Re:
1320 Hollywood Blvd
Hollywood, Florida 33019
Architect's Project #25075

DUBEY HISTORIC RESIDENCE
 1320 HOLLYWOOD BLVD
 HOLLYWOOD FLORIDA 33019

PLANNING COMMENTS | URJA MODI | umodi@hollywoodfl.org

Landscape Permit Plan
Dubey Residence
 1320 Hollywood Blvd.
 Hollywood, Florida 33019

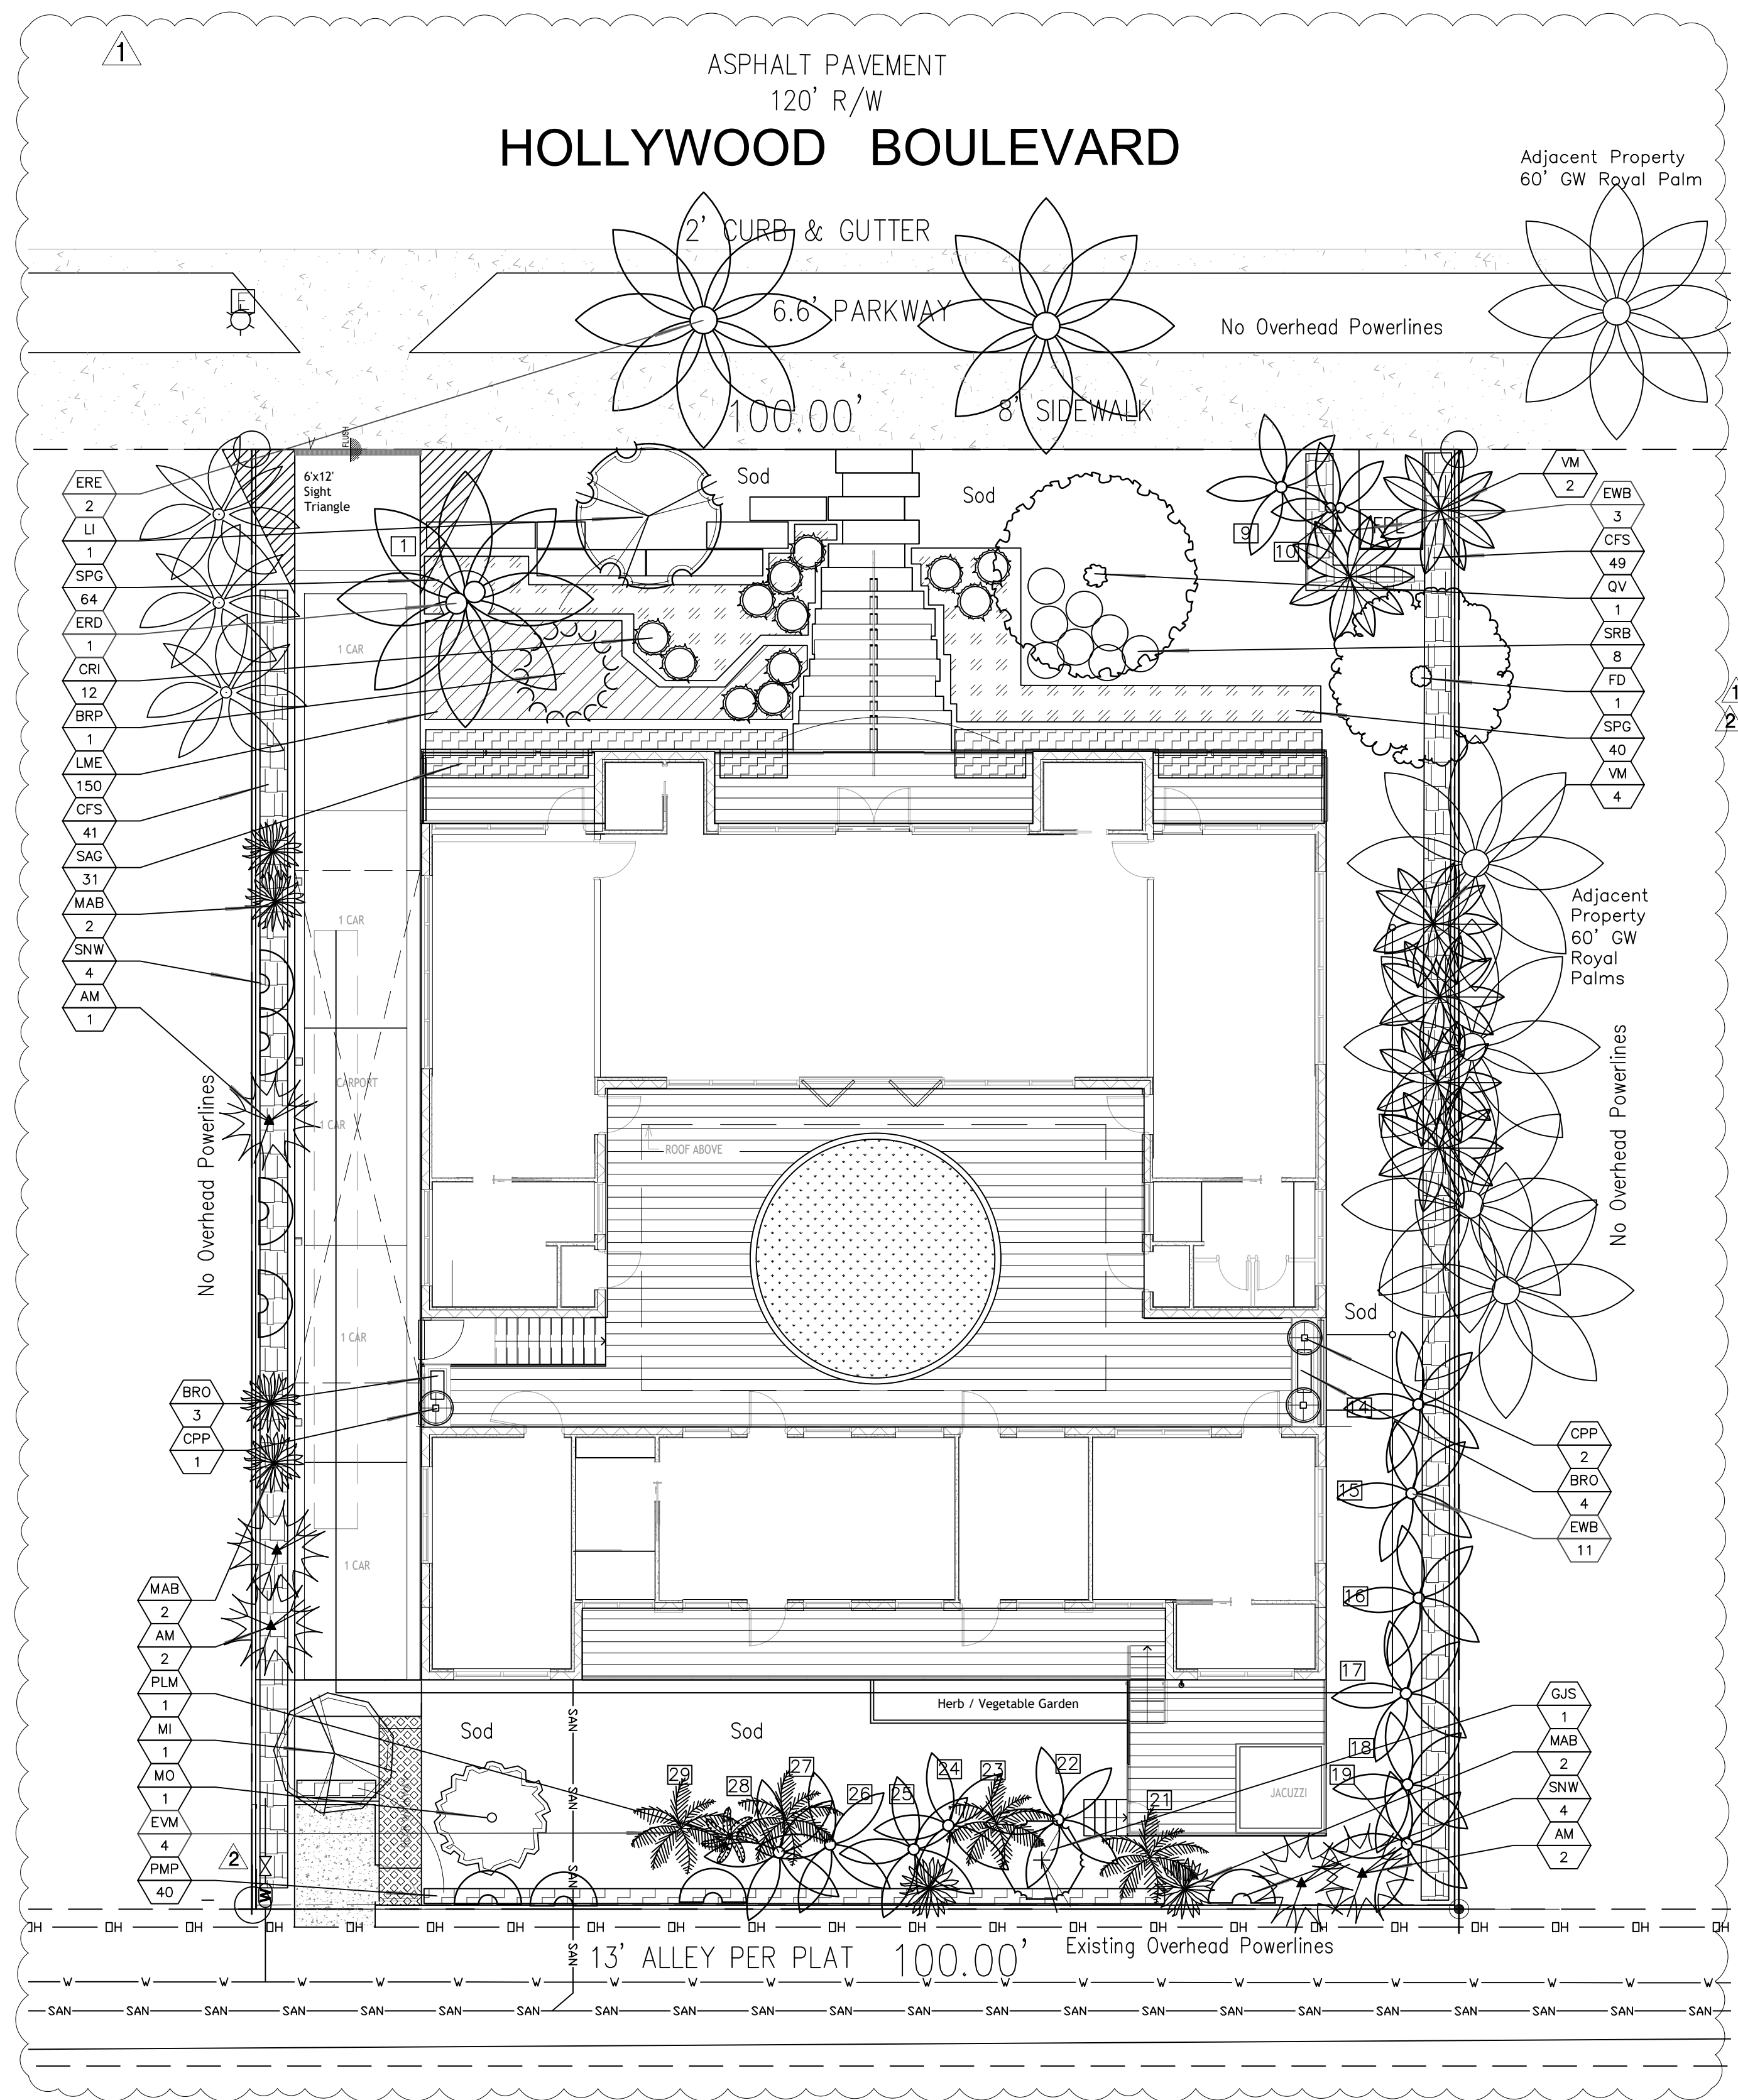
A. Existing trees/palms to be numbered on the landscape plan, sheet L2. Provide alternate tree symbol for palms to remain.

B. Label all sides of property whether there are 'Existing Overhead Powerlines' or 'No Overhead Powerlines'. Provide FPL approved trees for planting under powerlines.

C. Trust fund payment fee is not correct. Shortfalls can be paid into the city trust fund at \$350 per 2" tree or palm that doesn't fit. Landscape plan shows additional areas where shortfalls can be placed. Provide (1) additional Royal palm with min of 8' CT on swale area on East end. Provide (3) additional palm species with 8' CT on East or West perimeters.

D. Paving path from driveway to main front entrance is not matching between landscape plan and site plan. All plans to match.

RESPONSE: Numbered. REF.: SHEET L-1/L-2.

RESPONSE: All Sides Labeled REF.: SHEET L-2.

RESPONSE: Palms added. REF.: LANDSCAPE SHEETS.

RESPONSE: Plans coordinated. REF.: LANDSCAPE SHEETS.

Irriation Permit Plan
Dubey Residence
1320 Hollywood Blvd.
Hollywood, Florida 33019

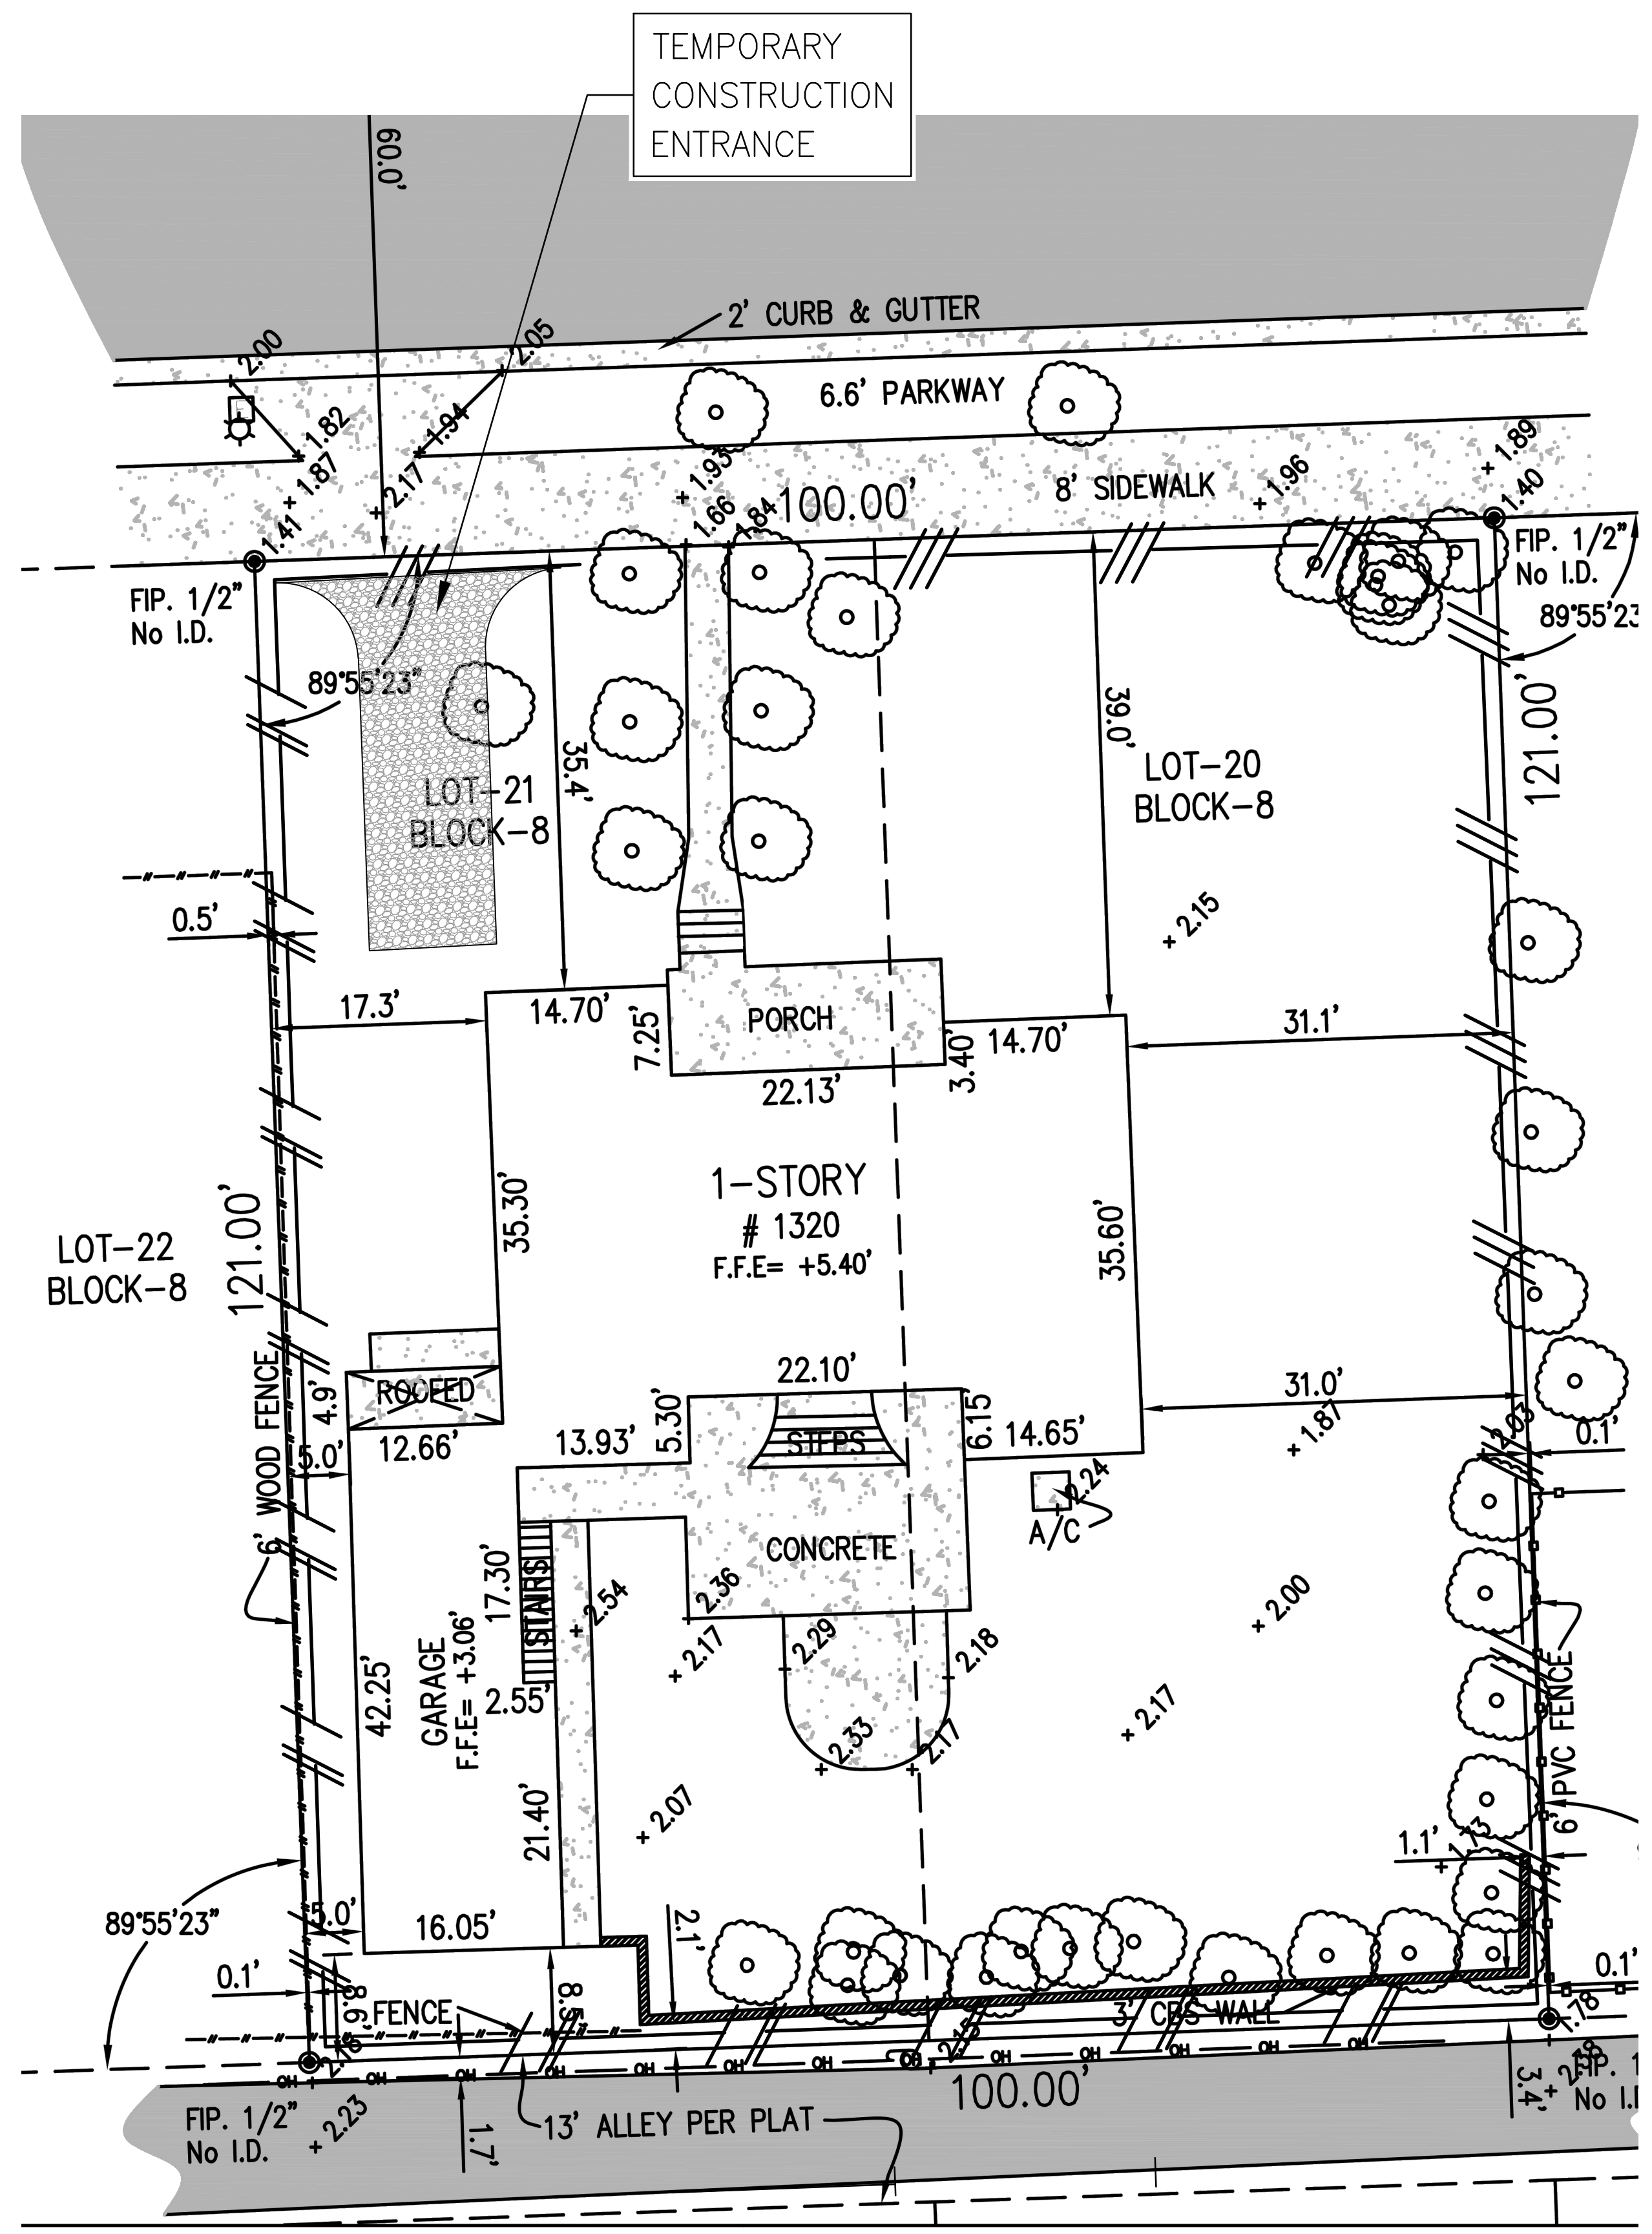
B. Sheet L-3 proposes irrigation service to meter along Hollywood Blvd. All water services shall be connected to the City's existing water main located within the alley south of Hollywood Blvd along the southern rear of the property. Coordinate with Sheet C-04. If a second, separate irrigation meter is proposed, specify size and relocate to rear near existing water meter.

RESPONSE: L-3 and C-04 coordinated and Irrigation connected from Existing Water Meter at Rear Alley. REF: Sheet L-3 and C-04.
